2020 Paving Project(s) – Phase II

Heritage Elementary School

ADDENDUM NO. 2

January 28, 2020

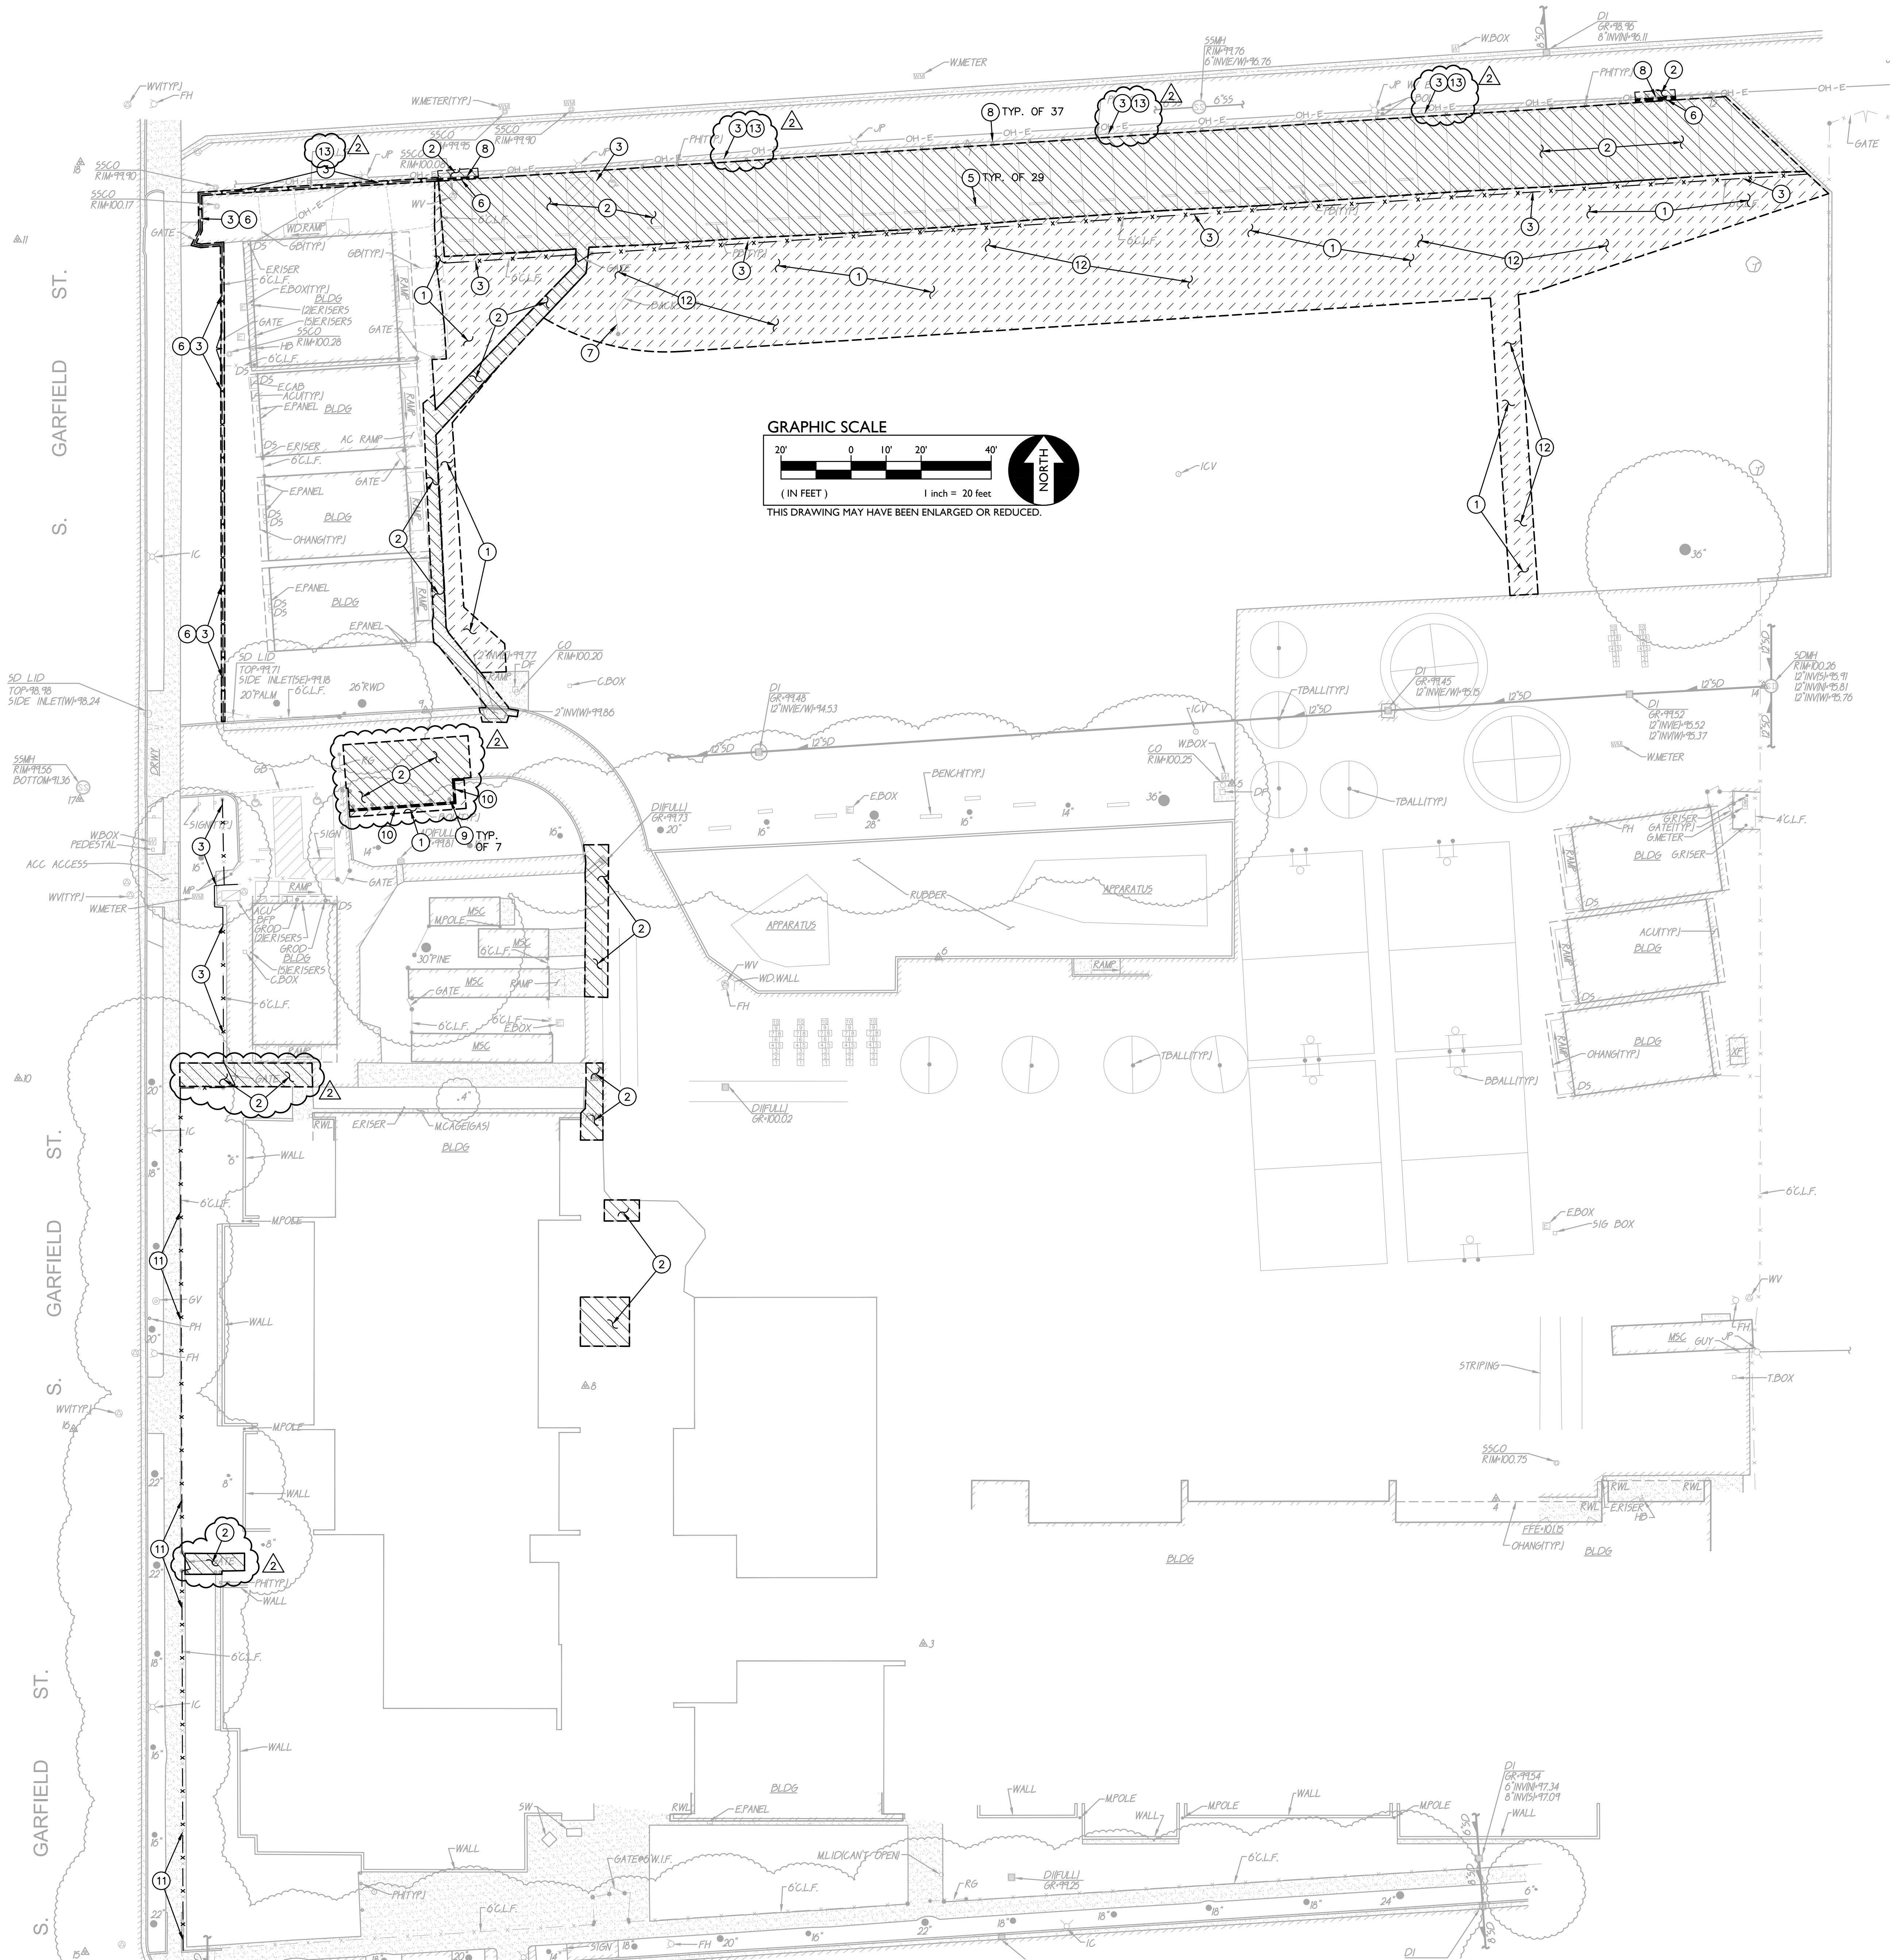
- 1.10 **Question:** It was noted at the job walk that the entire section of concrete which has the cut off posts in the concrete strip is to be removed. However per sheet C1.1 note 8 states remove posts and associated footing "typ of 37". C1.1 also only shows two spots where the demolition limit encroaches on this area. Please clarify what is to be removed at this location.

Response: No
- 1.13 **Question:** There are some areas on the demo plan that show us removing asphalt next to some post holes but are not shown to be paved back on any sheet. Is this the intent?

Response: Refer to Drawing Sheet C1.1, Note 12.
- 1.15 **Question:** The trash enclosure is shown to be poured neat against the existing asphalt. Is this the intent or do you want a 1-2' strip of asphalt patch back to help with the transition?

Response: Refer to Drawing Sheet C1.1 Demolition Plan, dated 01/27/2020 for clarification.
- 1.11 **Question:** For bidding purposes are we to assume standard colors for the CMU? And do we assume smooth or split face?

Response: Refer to Drawing Sheet C1.1 Demolition Plan, dated 01/27/2020.
- 1.14 **Question:** Is the contractor responsible for reconstructing the irrigation or will the school district do it? If the contractor is responsible for the cut, cap, and moving of said irrigation can we have an as-built pan of sort so we can see the extent of the work?

TITLE:	PROJECT:	SHEET NO.	PAVING PLAN	HERITAGE ELEMENTARY SCHOOL PAVING PHASE II LODI USD	SAN JOAQUIN CO., CALIFORNIA	DESIGNED: TF	NO.	DESCRIPTION	DATE	AGENCY APPROVAL	DATE	BY	HORIZONTAL SCALE:	AS NOTED	VERTICAL SCALE:	JOB NO.:	BENCHMARK NO.	ELEV.
<div></div> <div></div>

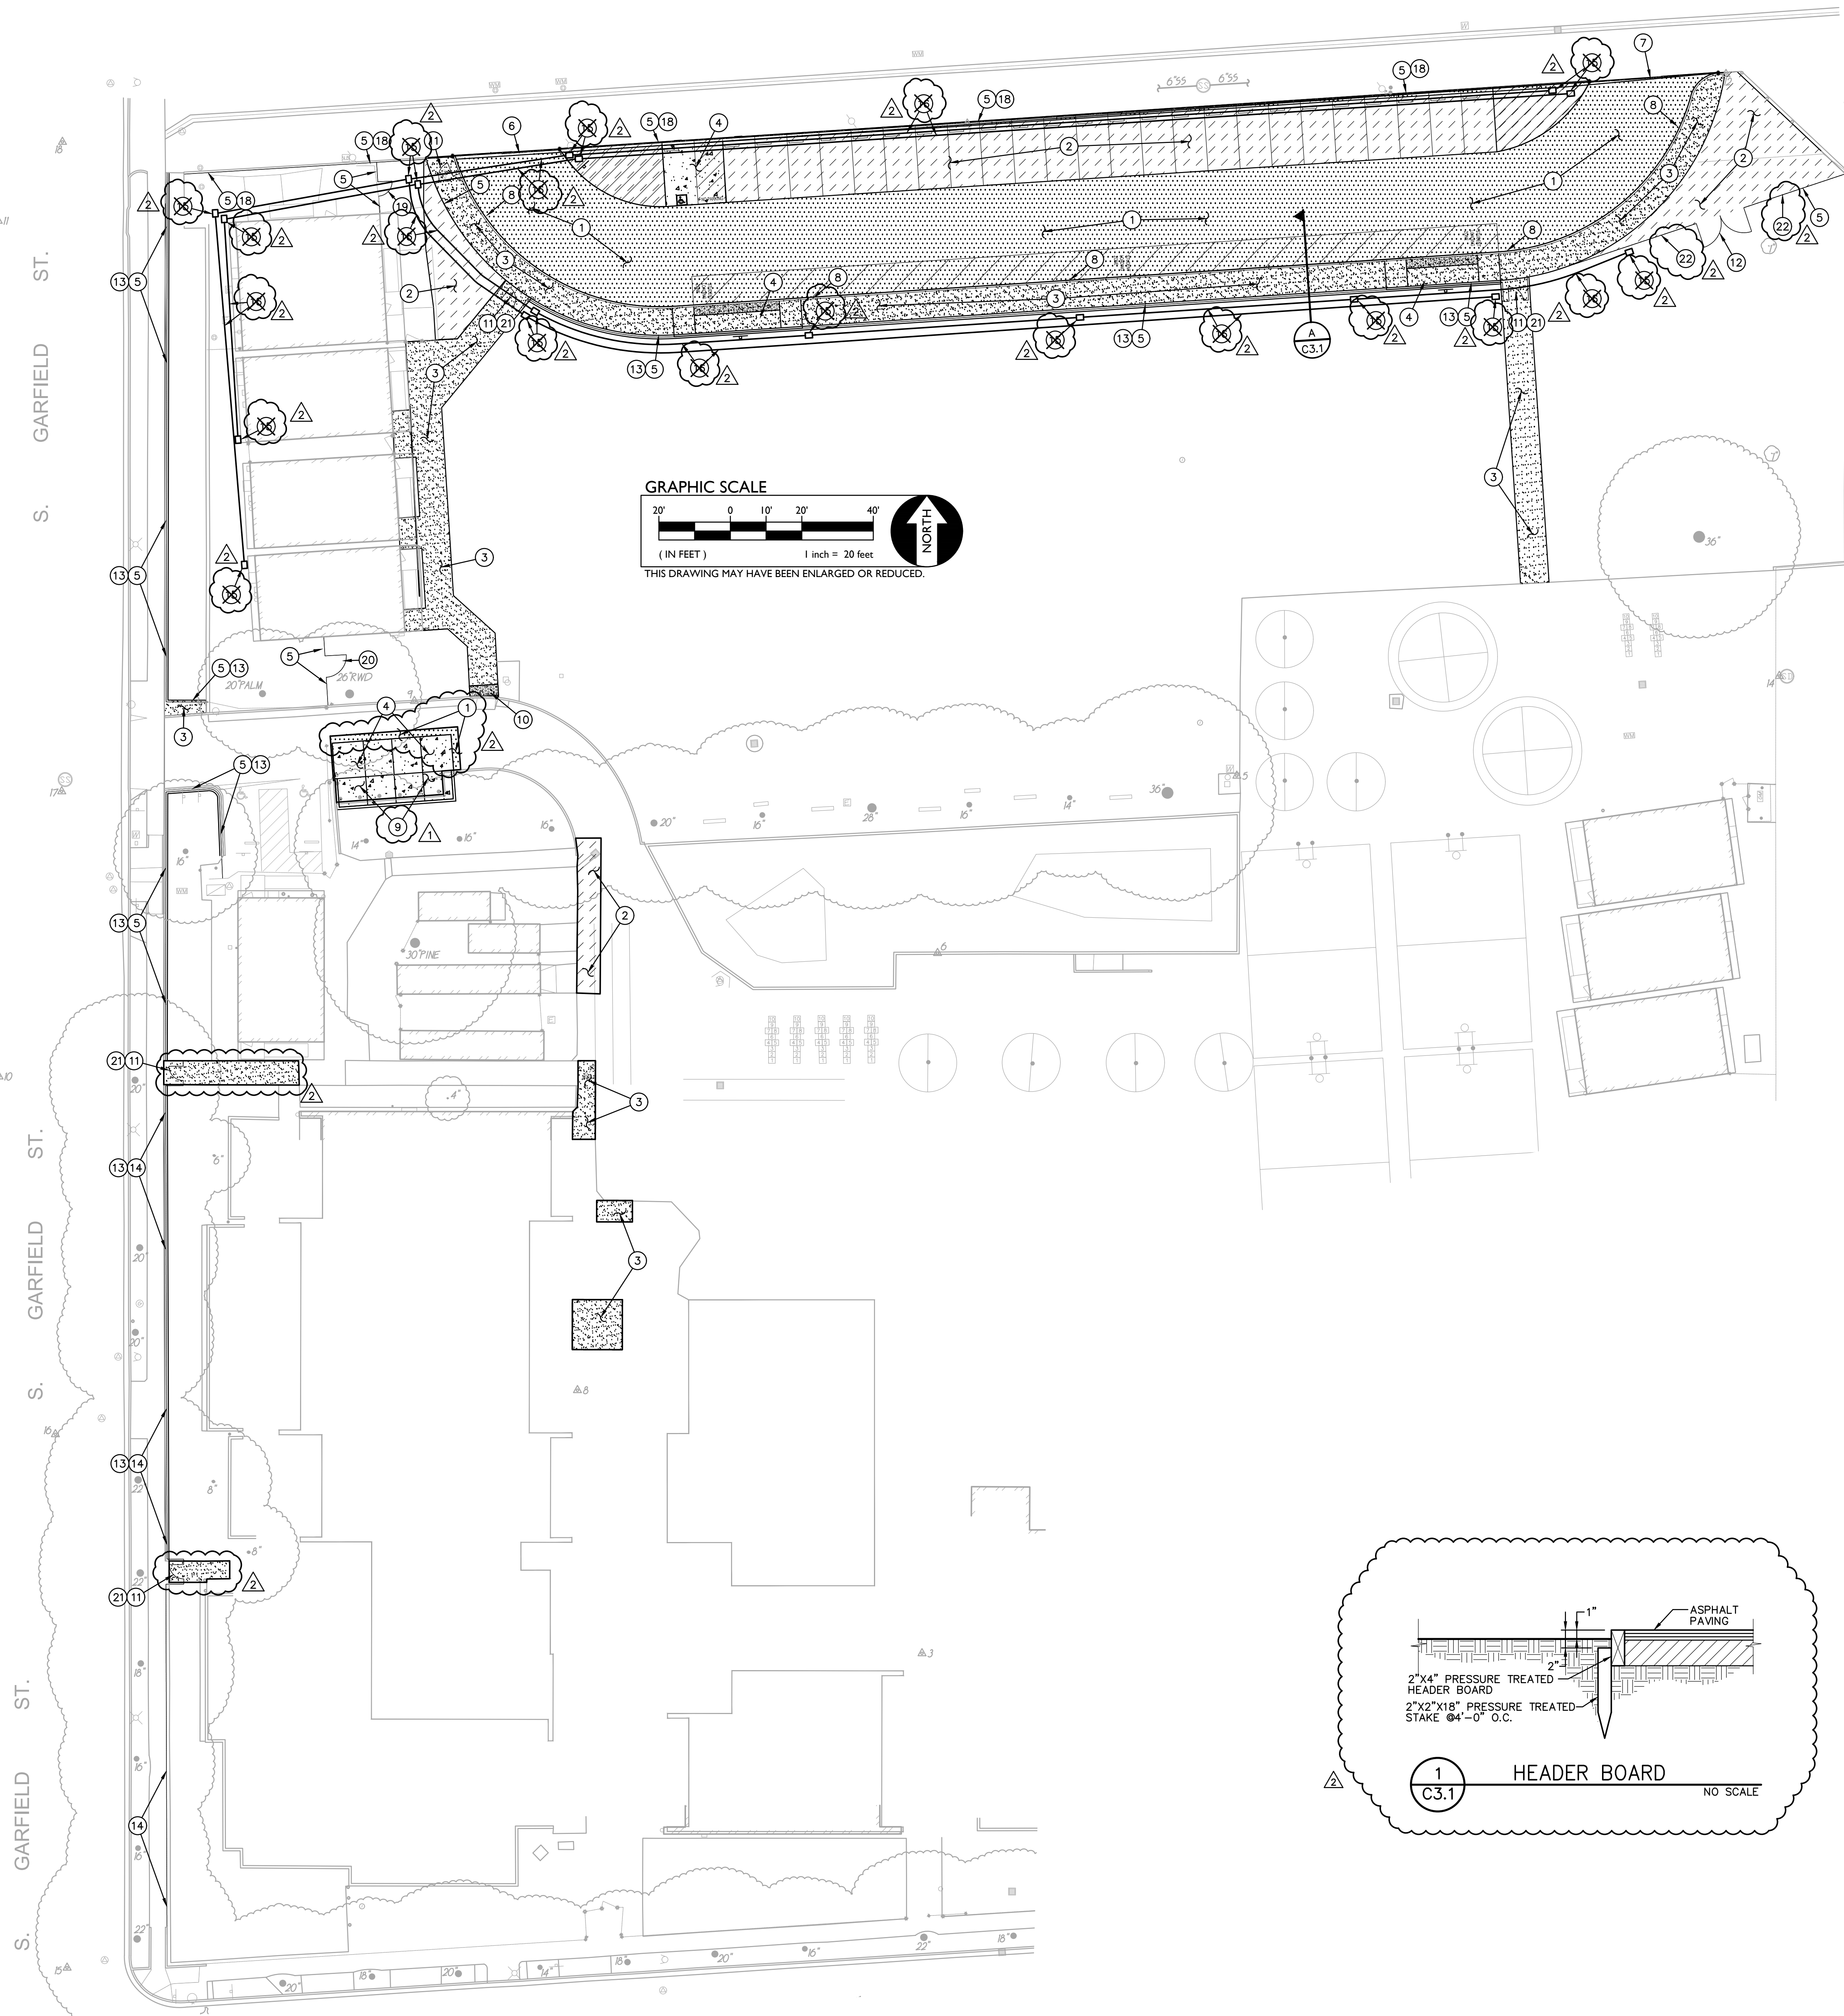
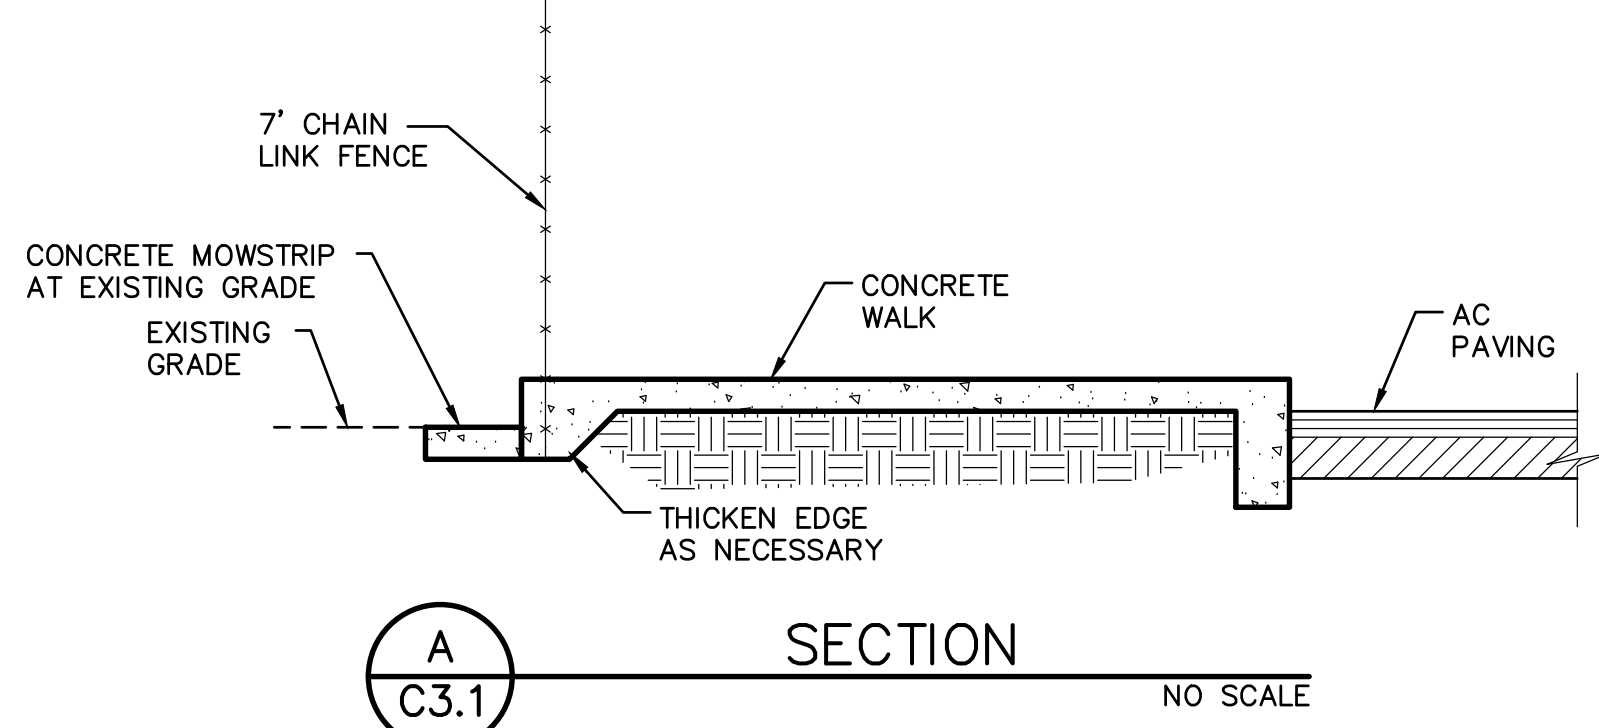
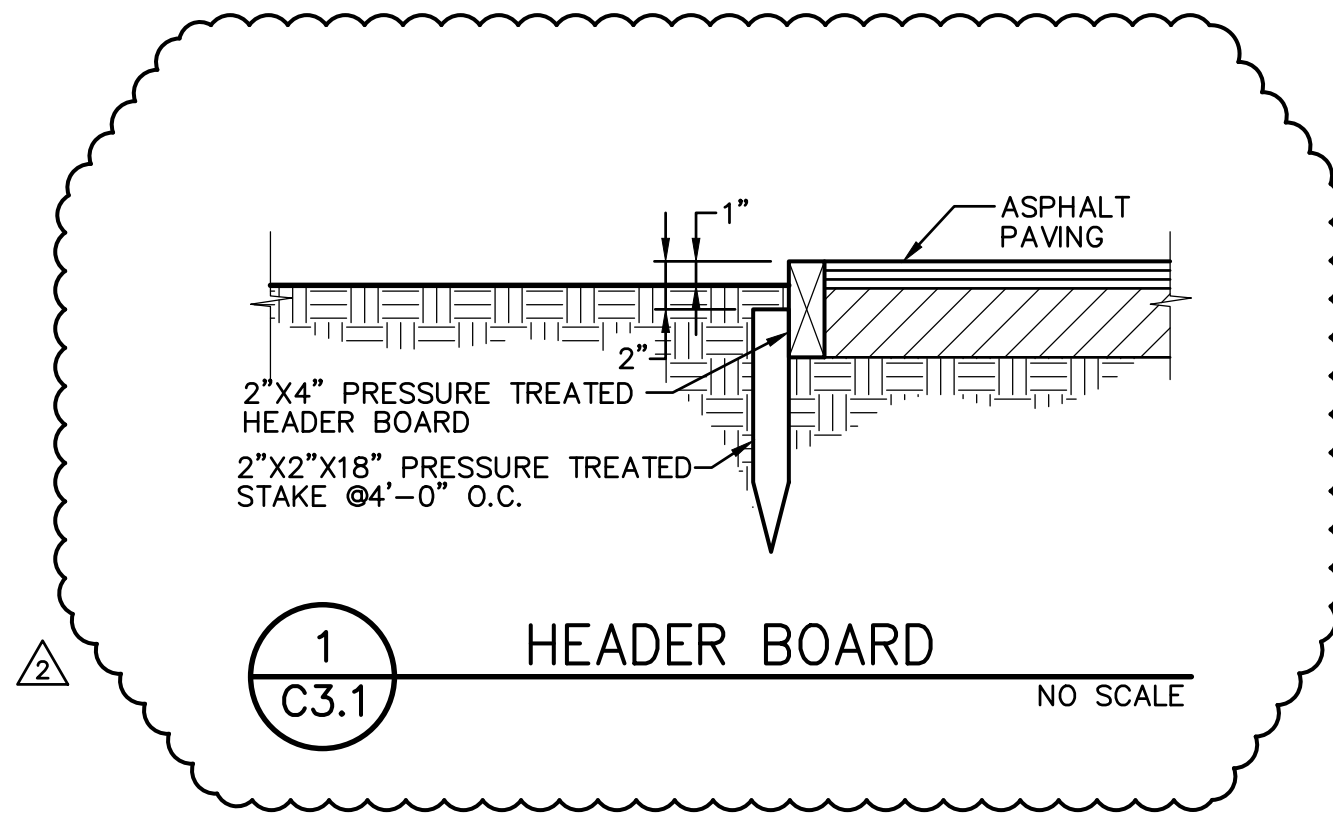
- 1.9 **Question:** Per specification section 00 11 16-1 provides the general scope of work which notes "lighting..." however it does not appear that there is lighting on the plans. Please advise.

Response: Refer to Drawing Sheet C3.1 Paving Plan, dated 01/27/2020.
- 1.16 **Question:** What work is to happen at the areas calling for a 60" min landing at the gate entrances on sheet C3.1?

- 1.23 **Question:** Does there need to be a header board where asphalt is directly adjacent to landscape areas? If so what type and size?
Response: Yes. Refer to Drawing Sheet C3.1 - Paving Plan, dated 01/27/2020 for clarification.

- 1.24 **Question:** Note 16 on sheet C3.1 calls for 2 conduits but is pointing to two different lines. So are there 2 conduits or 4 conduits running to the pull boxes?

Response: Delete all the conduit notes on sheet C3.1. Refer to Drawing Sheet C1.1 Demolition Plan, dated 01/27/2020. Also refer to Drawing Sheet E100 Partial Site Plan – Electrical, dated 01/24/20 for clarification.

Response: Refer to Addendum 1 Drawing Sheet C3.1 Paving Plan, dated 01/27/2020.
- 1.17 **Question:** Will temp fence be required around the project?
Response: Yes.
